UNITED STATES PATENT AND TRADEMARK OFFICE

| APPLICATION NO. | FILING DATE | FIRST NAMED INVENTOR | ATTORNEY DOCKET NO. | CONFIRMATION NO. |
|-----------------|-------------|----------------------|---------------------|------------------|
| 10/602,610 | 06/25/2003 | Anthony Pidcock | 84689 3006 KAW | 2474 |

Office Action Summary

DETAILED ACTION

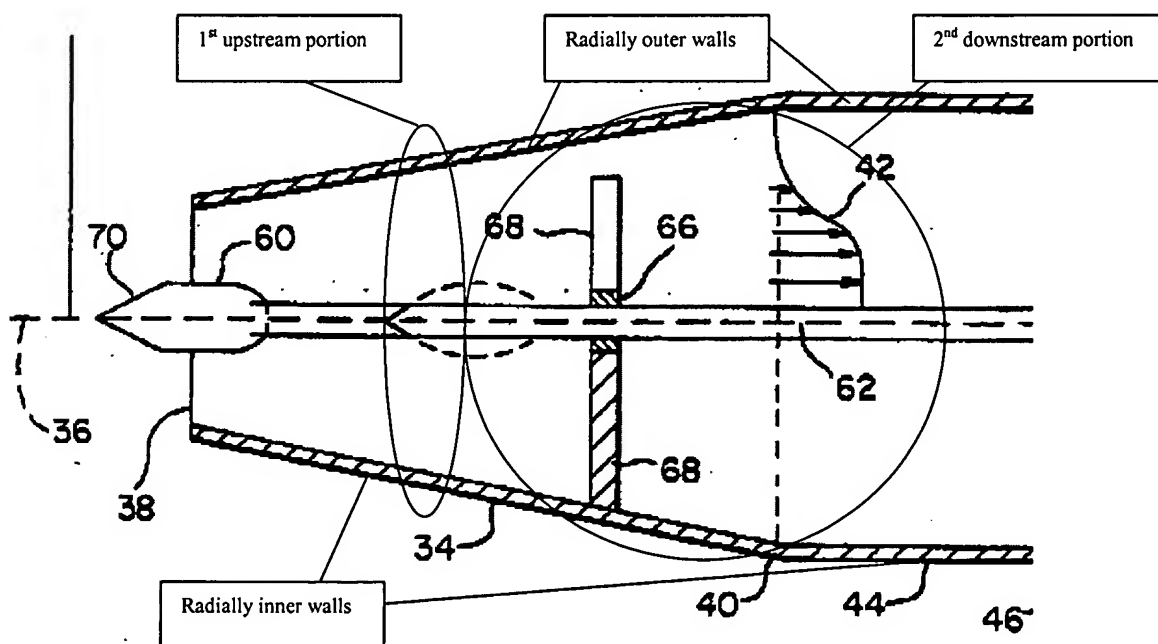
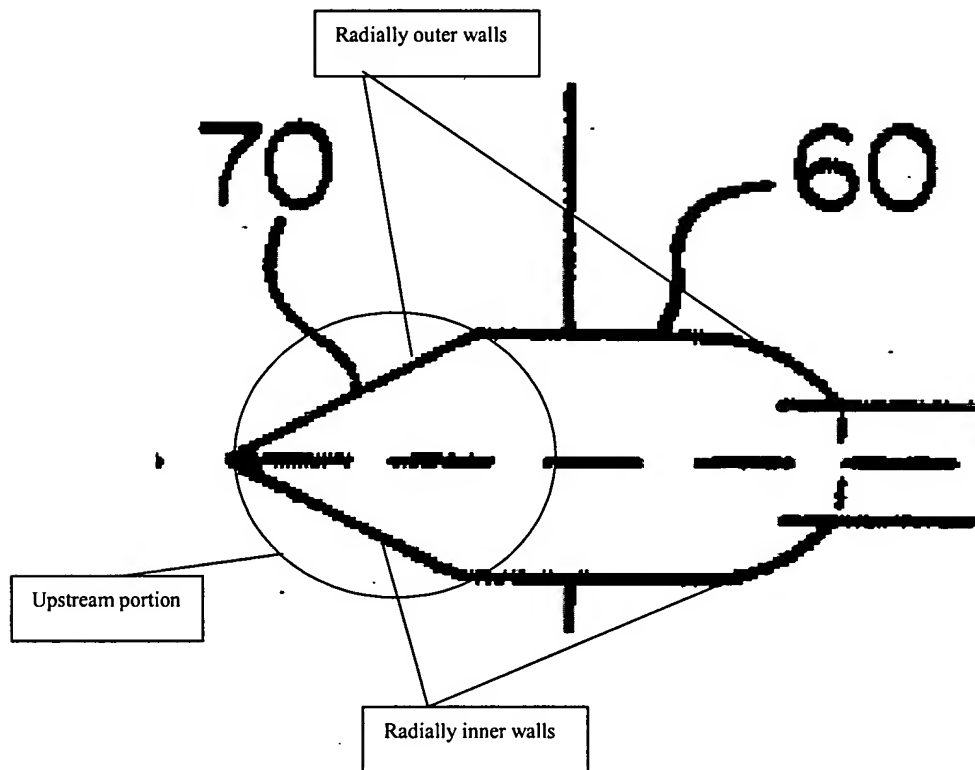
With respect to claims 1 and 12, **Stroem** teaches a gas turbine engine comprising: a diffuser 16 located between a compressor 10 and a combustor 22, the diffuser being generally annular, including radially inner and radially outer walls and a generally cylindrical midline 36 defined between the walls, wherein the diffuser is shaped to include a first upstream portion in which air flowing through the diffuser is directed away from the midline and a second downstream portion in which air flowing through the diffuser is directed at least partially towards the midline of the diffuser. See **Figure 1** above and cl. 2 ll. 43-47, cl. 4 ll. 11 to cl. 5 ll. 2.

With respect to claim 2, **Stroem** teaches that the diffuser includes a generally annular central member 60 located between the radially inner and radially outer walls, airflow through the diffuser being forced to separate and pass around the central member. See **Figure 1** above.

With respect to claim 3, **Stroem** teaches that the central member includes an upstream portion which includes radially outer and radially inner walls, each diverging away from the midline 36 of the diffuser in the downstream direction, causing air flowing around the upstream portion or the central member to be directed away from the midline of the diffuser. See **Figure 1** above.

With respect to claim 4, **Stroem** teaches that the walls are angled at between 20 to 90 degrees. Measurement by a protractor of the angle of the walls of the diffuser and central member of Figure 1 resulted in angles within the claimed range of 20-90 degrees. See **Figure 1** above.
